# STORM SEWER IMPROVEMENTS to serve part of MILL CREEK 1020 E 19th St. N City of Wichita, Kansas

Paul Gunzelman, P.E. Interim City Engineer  
Project Number 2023-000827 PPD (56030970)

**AS-BUILT**  
04/09/2024 11:06:54 AM

LUMBER YARD  
TITLE SHEET  
WICHITA, KANSAS

LUMBER YARD  
**SITE PLAN**  
WICHITA, KANSAS

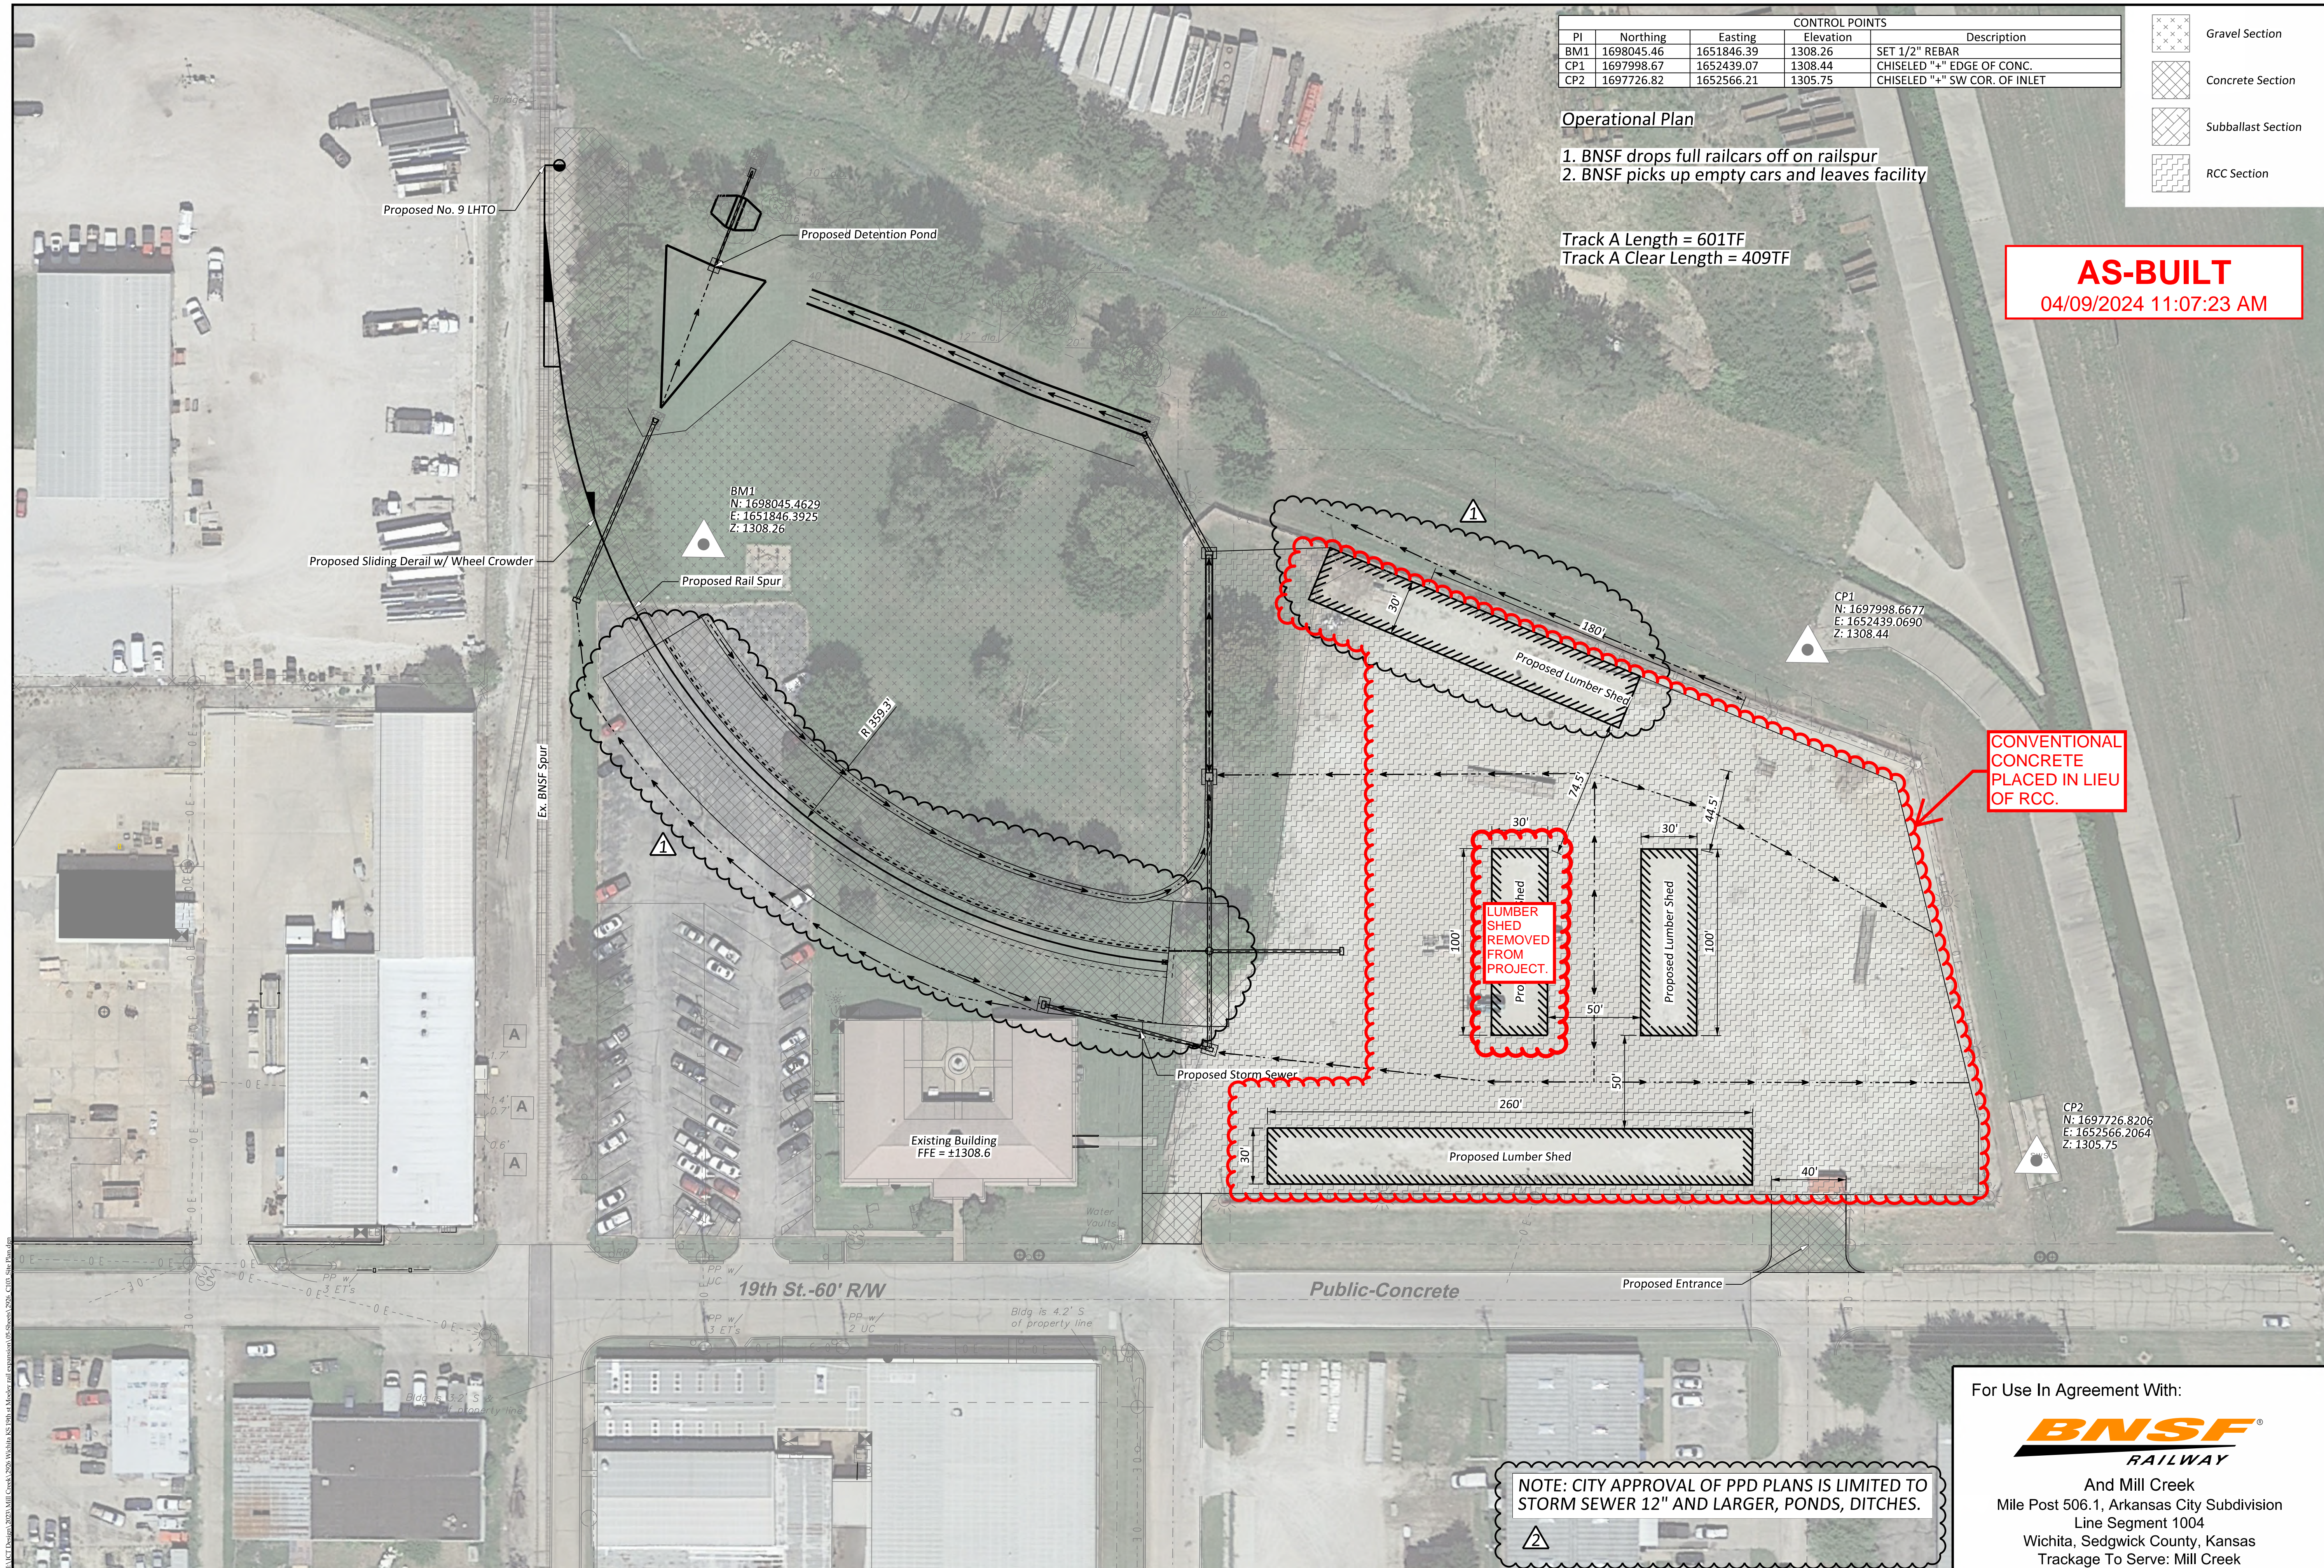
CONVENTIONAL CONCRETE PLACED IN LIEU OF RCC.

LUMBER SHED REMOVED FROM PROJECT.
